**SECTION 00 90 03
BIDDING AND CONTRACT REQUIREMENTS
ADDENDUM NUMBER 3**

Re: ADDENDUM NUMBER (3) TO THE BIDDING DOCUMENTS FOR

**McHenry County College
University Center at MCC**
Architect's Project Number: 22-050

SHEET NUMBER:
A5.01

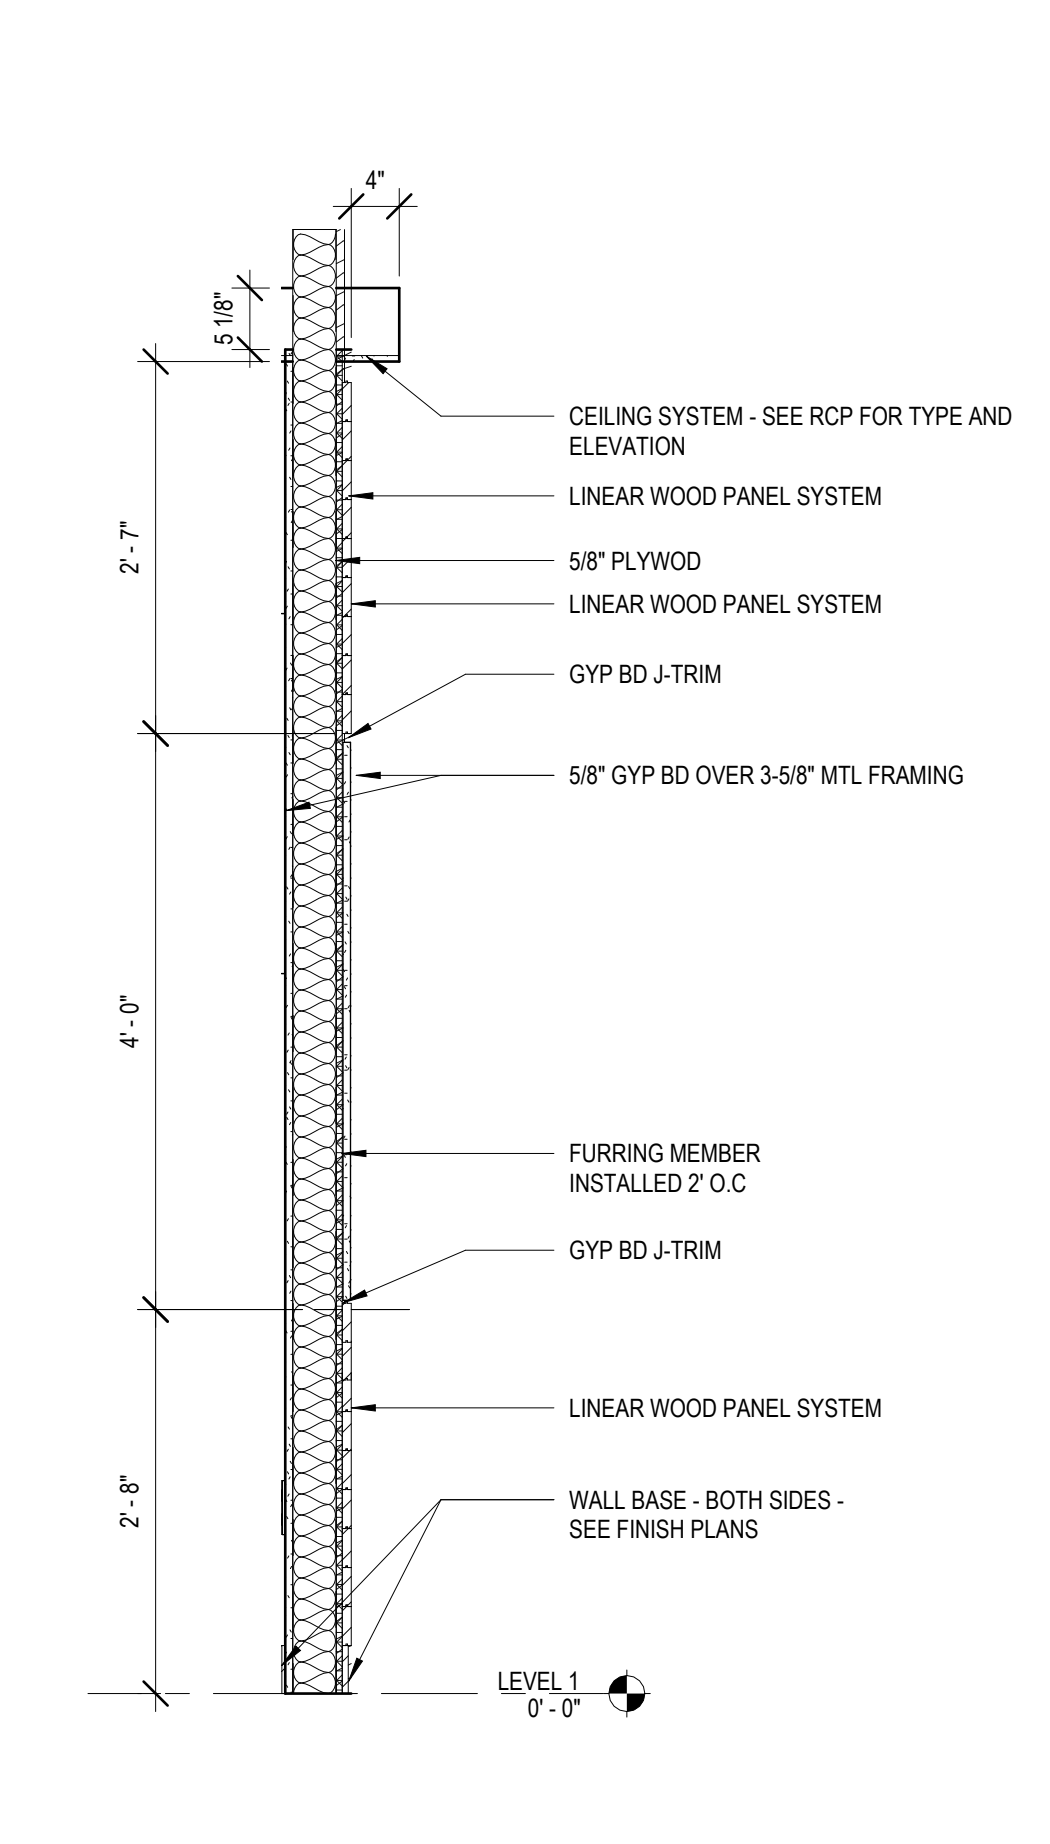
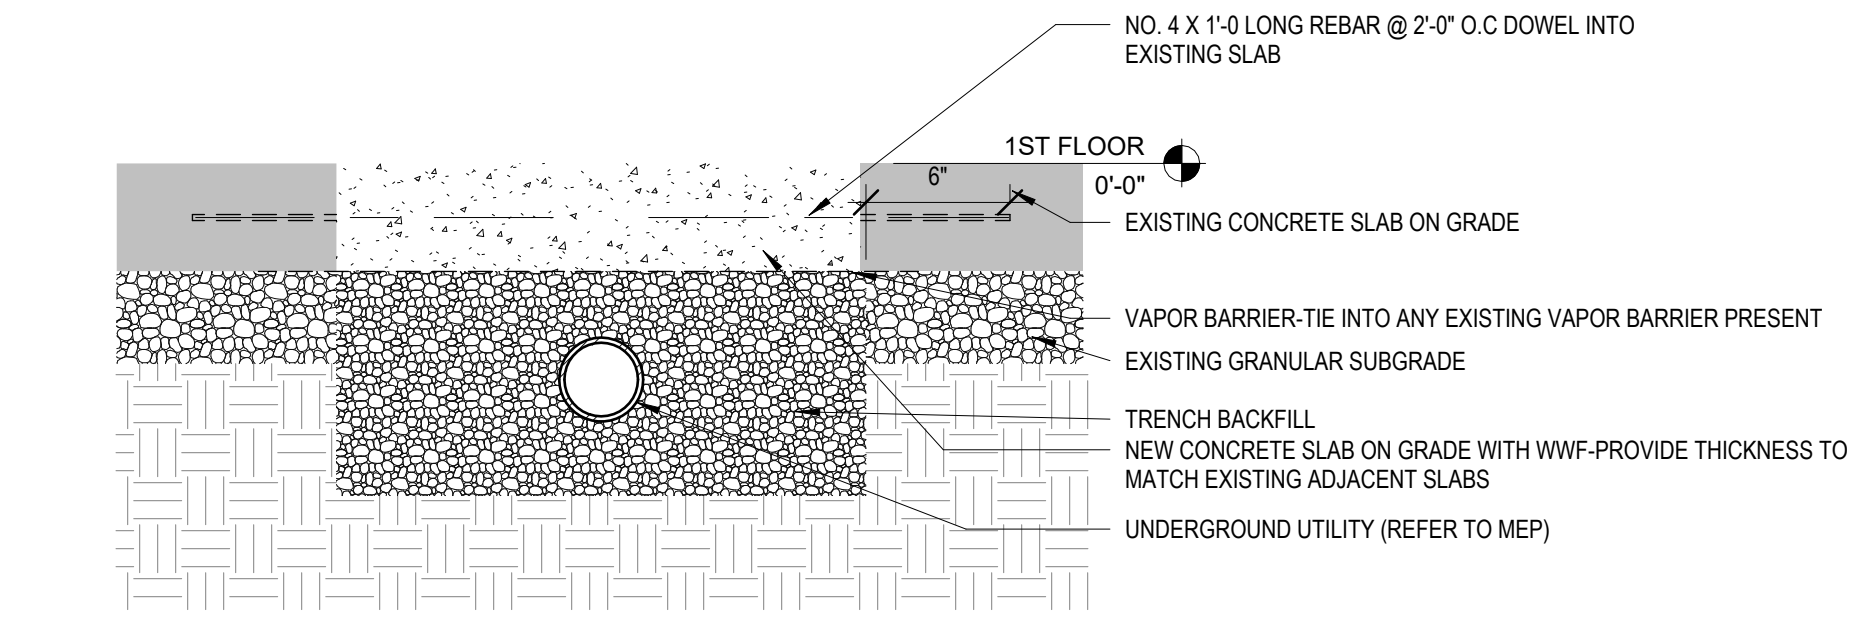
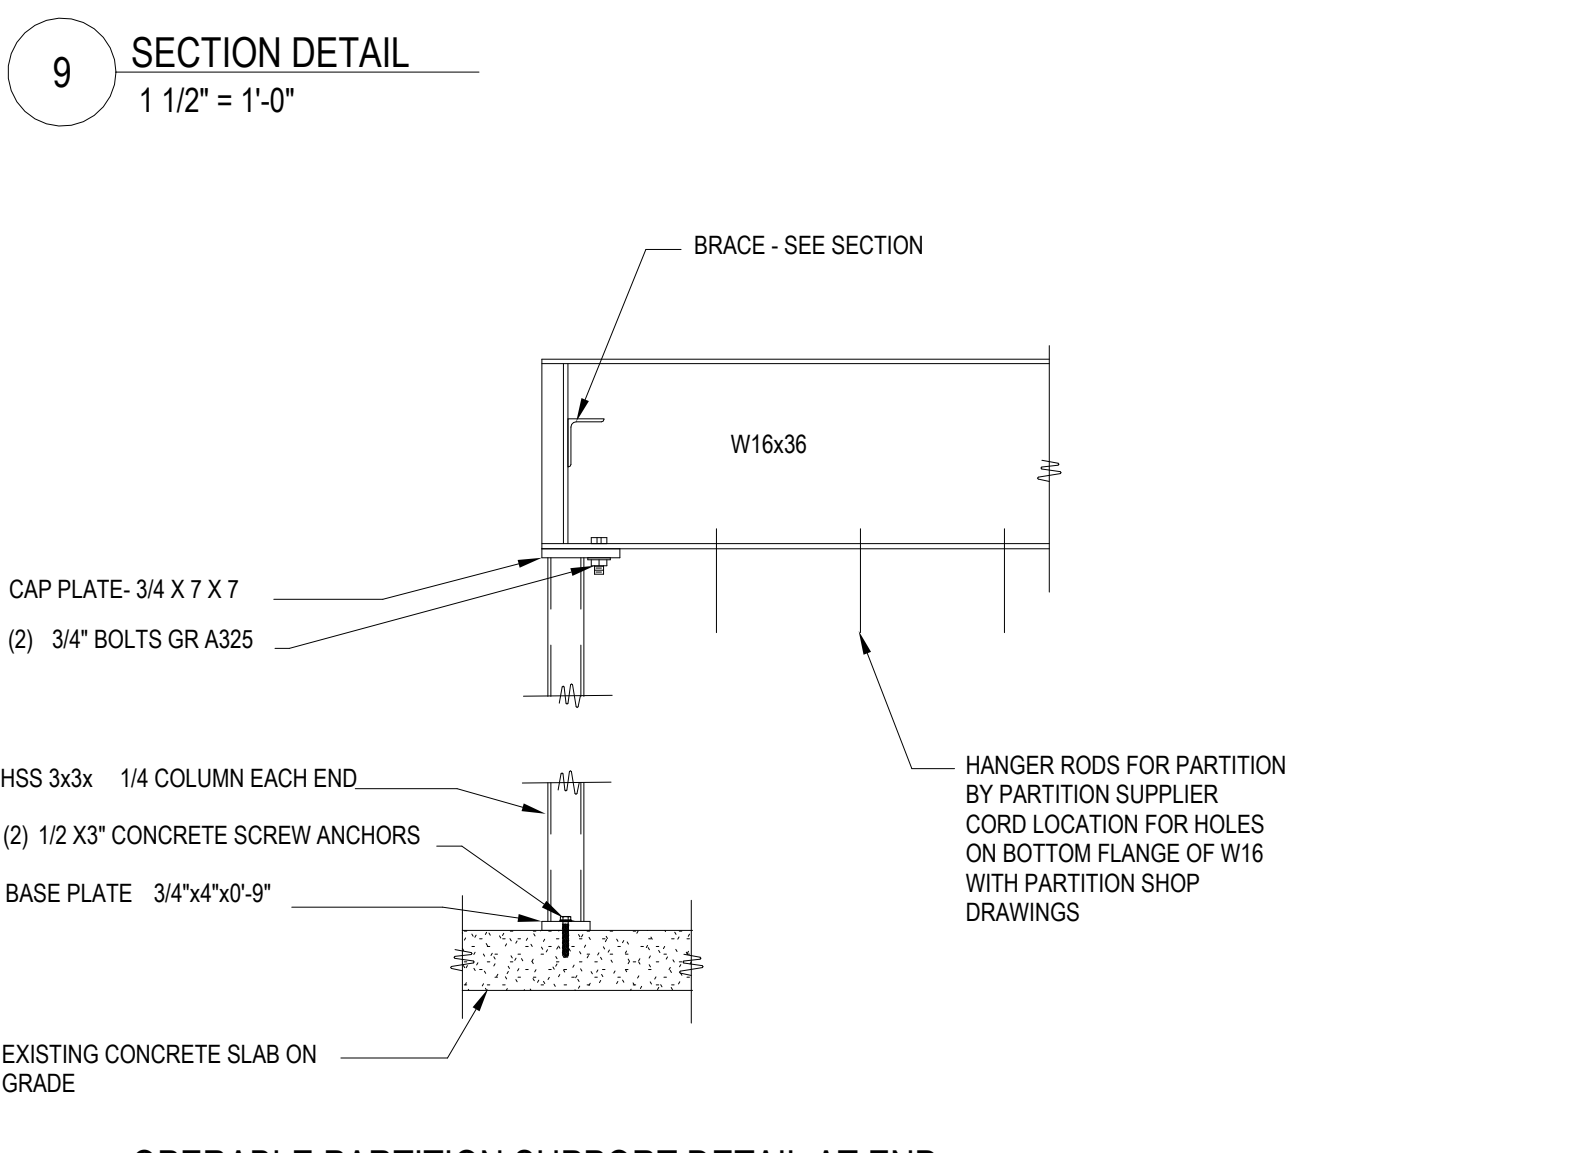
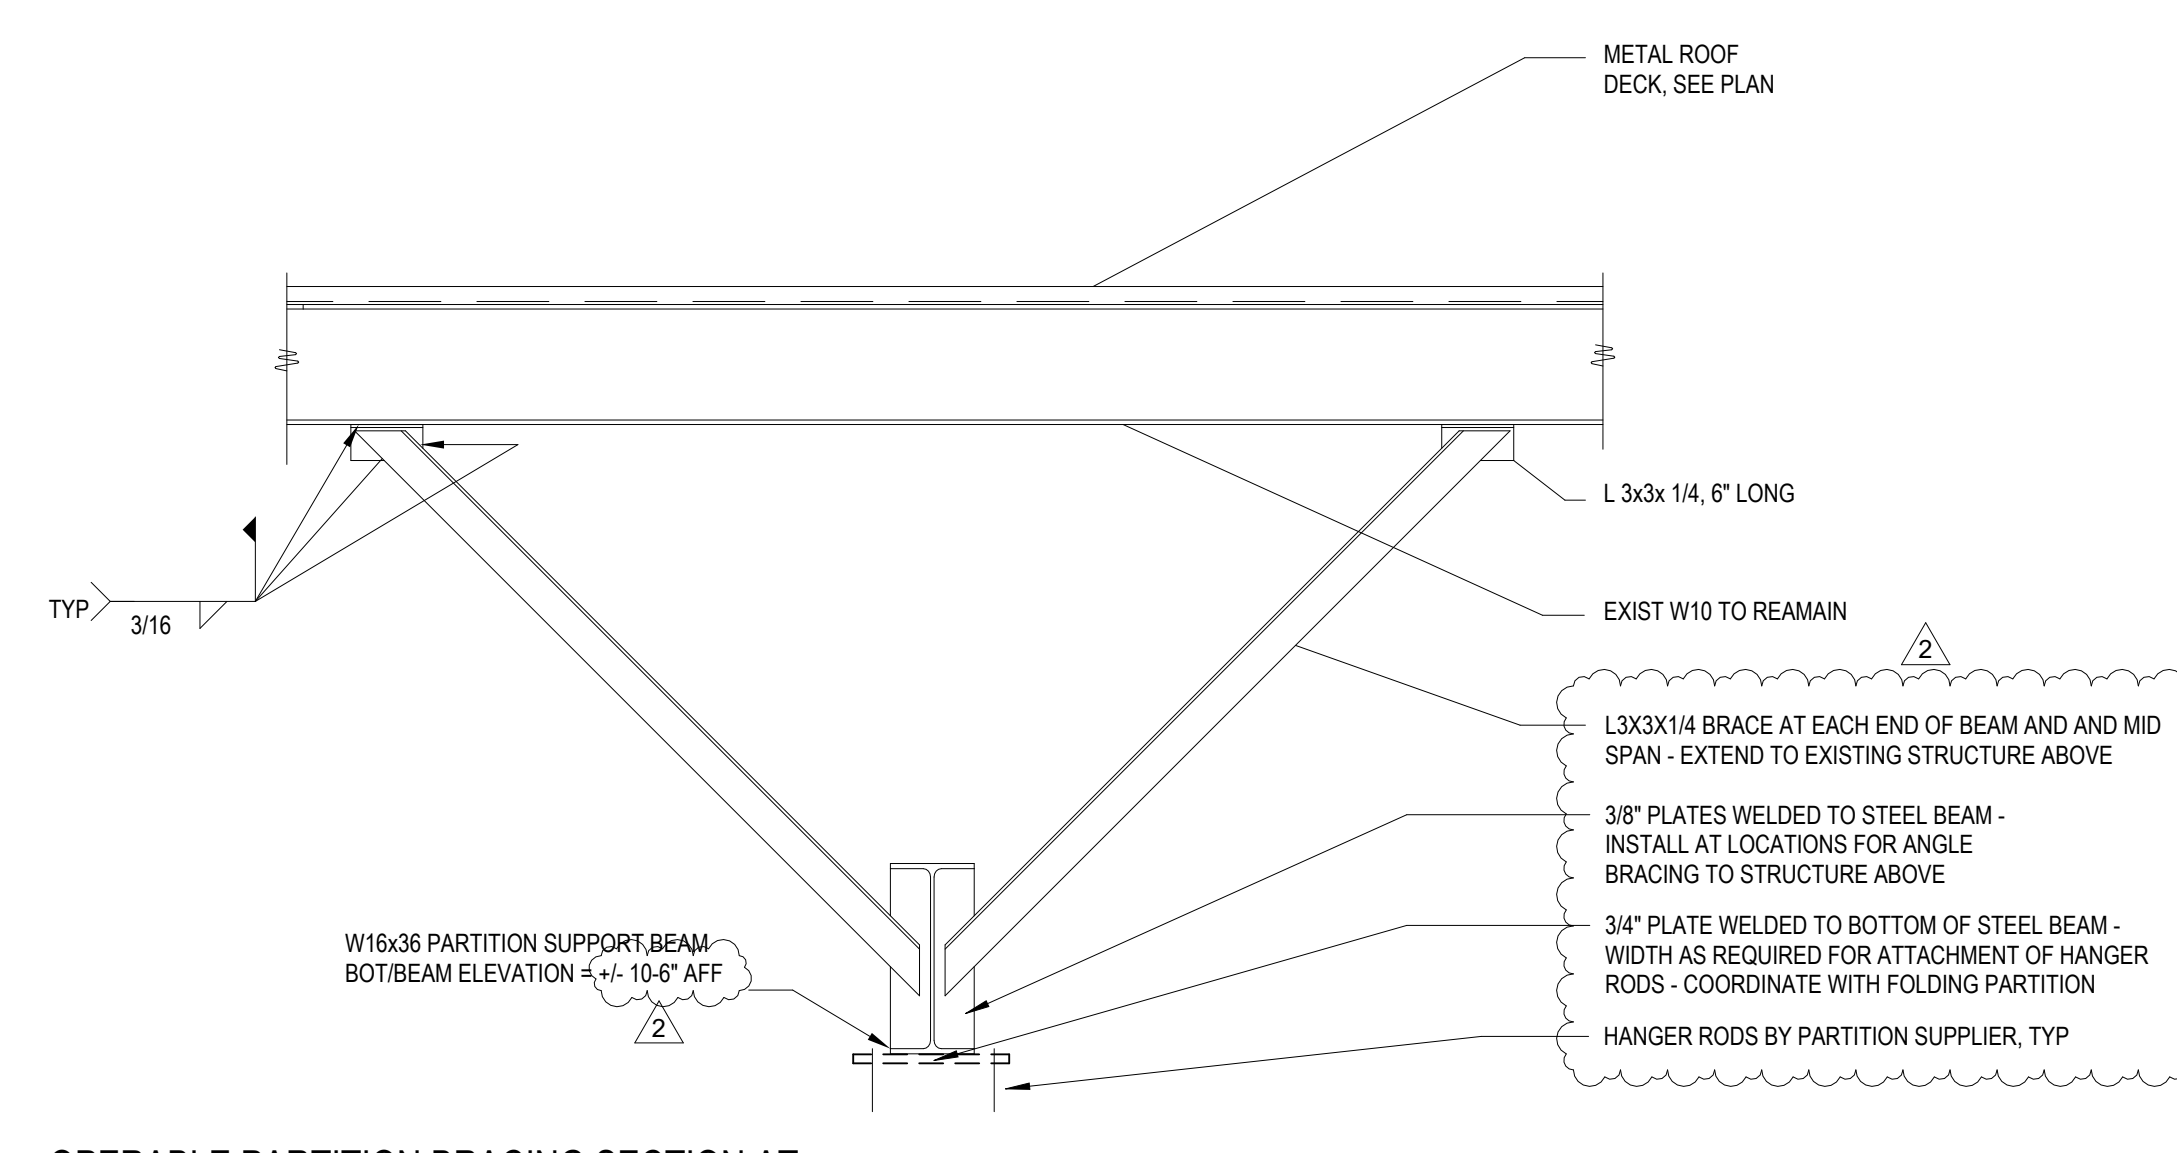
6. A5.01
 - A. **REVISE** section 1 as indicated to reflect section condition and sim conditions.
 - B. **REVISE** detail 11 as indicated.
 - C. **ADD** section 12 as indicated through window elevation A.
7. A9.51 / A11.01
 - A. **REVISE** WD-1, WD-2, WD-3, WD-4, and CP-1 as indicated.
8. A10.00
 - A. **REVISE** door and frame schedule as indicated.
 - B. **REVISE** detail numbering for numerical order. Clouds not indicated for clarity.
 - C. **REVISE** glass type indicated for window elevation A to GL-02 as indicated.
